Affected Models:
All Emira Models

Number:
131-26018

Carconfig update on EmiraDS.

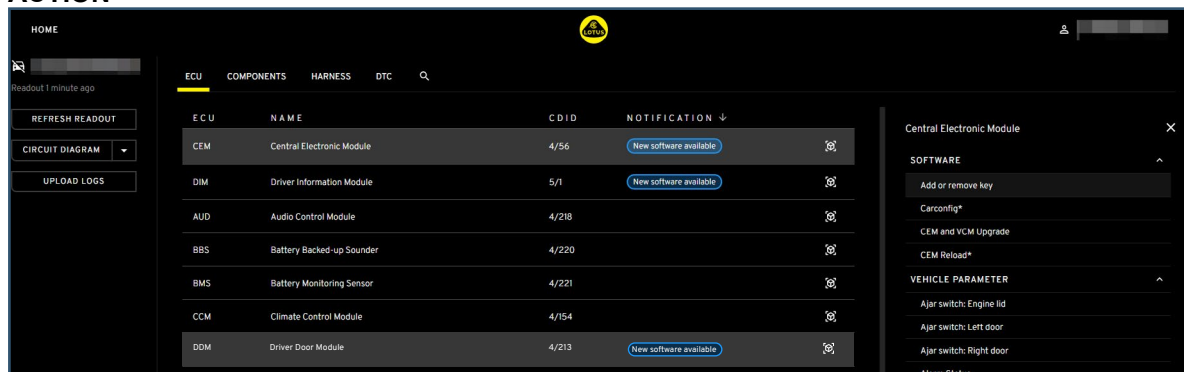
Because the Carconfig is a common file shared across all ECU software packages, the “New Software Available” notification will be displayed on multiple ECUs, (except for CPC, EIS, EMS, FSCM, and TCM 2L ECUs).

This does not necessarily indicate that a specific upgrade is required for each ECU listed, but if a software notification is also available for the DDM (Driver Door Module), upgrading the DDM first will clear the notification for all other ECUs that do not have individually applicable upgrades.

If a vehicle connected to EmiraDS is displaying the “New Software Available” notification across multiple ECUs, then check to see if software notification is also available for the DDM. **Upgrade the DDM first** and then check to see if the “New Software Available” notification on other ECU’s has now been deleted.
